Preliminary Plat

Master Site Plan

Plan and Profile Sheets of Street and Utility

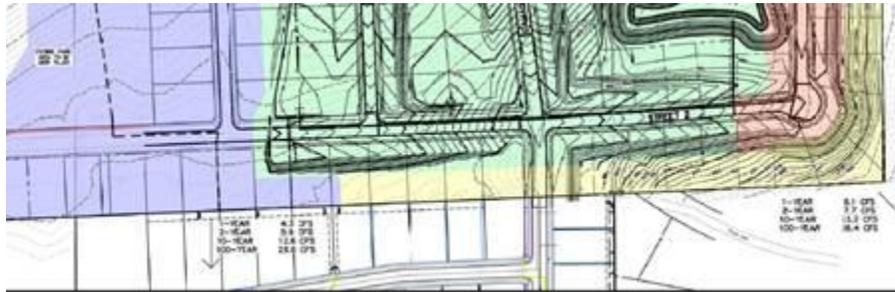
1. The Westlawn 4th addition plans appeared to call for capturing runoff from a larger area to the north than the 5th addition plans seem to accommodate flowing to the south. The image below is from the plans for the 4th addition that show the rear-yard swale extending from the parkland on the east to the second-over lot west of Damascus.

2. The next image shows the watersheds delineated as part of the 5th addition stormwater plan. This shows drainage from the north only coming from west of the central easement

between lots 363 and 364 of the 4th addition. Plans for the 5th addition don't seem to call for any infrastructure for the yellow area west of Damascus to collect/route the runoff. Additionally, it appears there will be quite a grade-break for the lots south of 'Street 2' and perhaps the proposed-conditions watershed boundary needs to be shifted slightly to the north? At a minimum, it appears watershed boundaries should be adjusted.
